Proposed Wanaka Industrial Zone Extension

LANDSCAPE ASSESSMENT

REPORT TO: Vicki Jones – Senior Policy Analyst, QLDC

REFERENCE: Plan Change 36 – Wanaka Industrial Zone Extension

Fig 1: 15m buffer with 3m mound and dense planting to 5 or 6m.

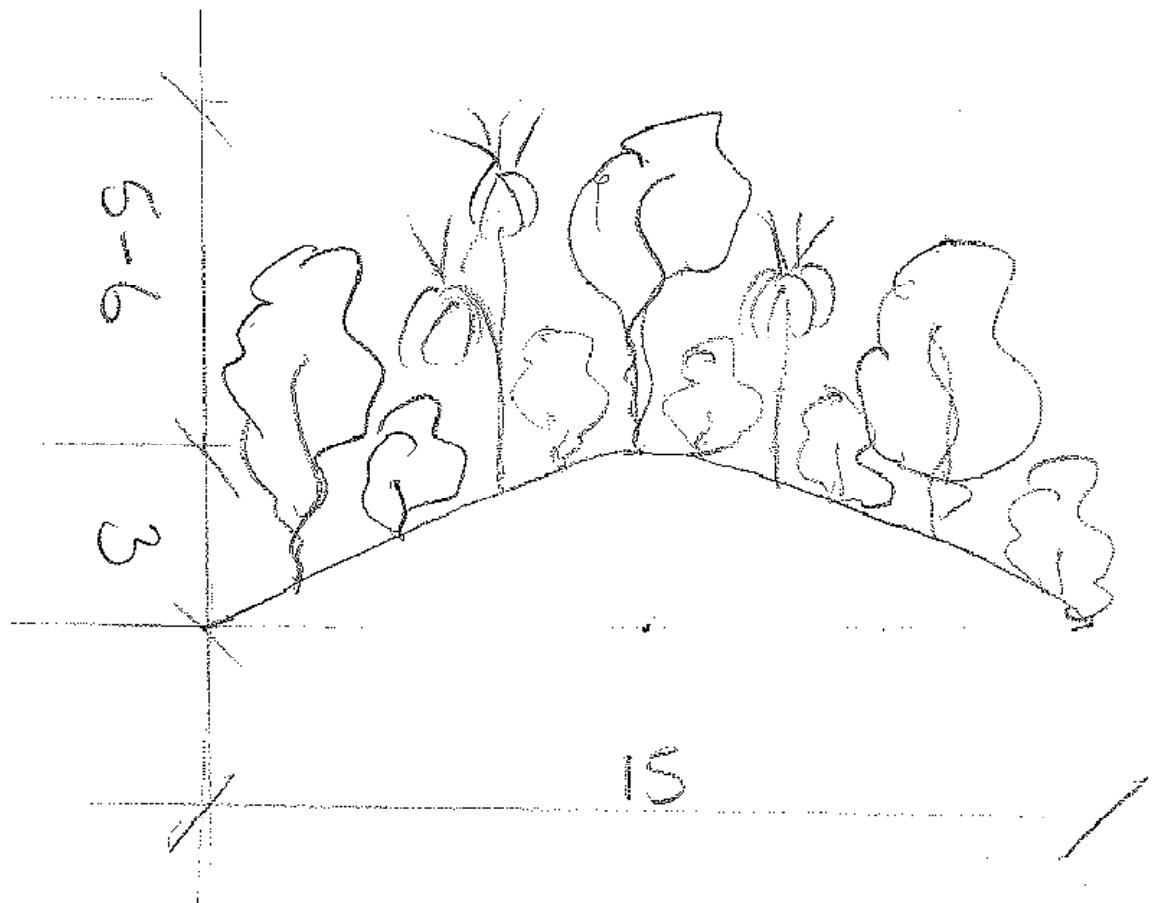
- 5.4 The main constriction on the width of the buffer strip is the ability to construct a bund within it and to plant it adequately to provide a dense screen. The final height of planting would also need to be adequate to provide screening but not so high as to create a shading problem for future development to the west and I consider approximately 8m in total would be appropriate. This would exceed the height of buildings within the industrial zone but not cause a shading problem. If planting was undertaken on a bund of, say, 3m in height species which reached approximately 5m would be adequate. I do consider that they should be evergreen and mixed indigenous species could provide an ecological as well as aesthetic benefit. In order to accommodate a bund of up to 3m high and planting I consider that the buffer strip should be 15m wide. As with the knoll, however, I do not consider that the buffer need be a reserve. Some private vehicle parking, for example, could be incorporated in the eastern side of it. If

this were to be the approach taken then the buffer strip would need to be wider, 20m as a minimum.

- 7.4 The buffer strip along the western margin of the site could be reduced in width to a minimum of 15m provided mounding was also used to mitigate noise effects on future residential development to the west. If mounding was not used 30m of dense planting would be the minimum necessary to mitigate noise effects as well as visual effects. The buffer if widened to 20m, could have low level uses such as vehicle parking incorporated within it.
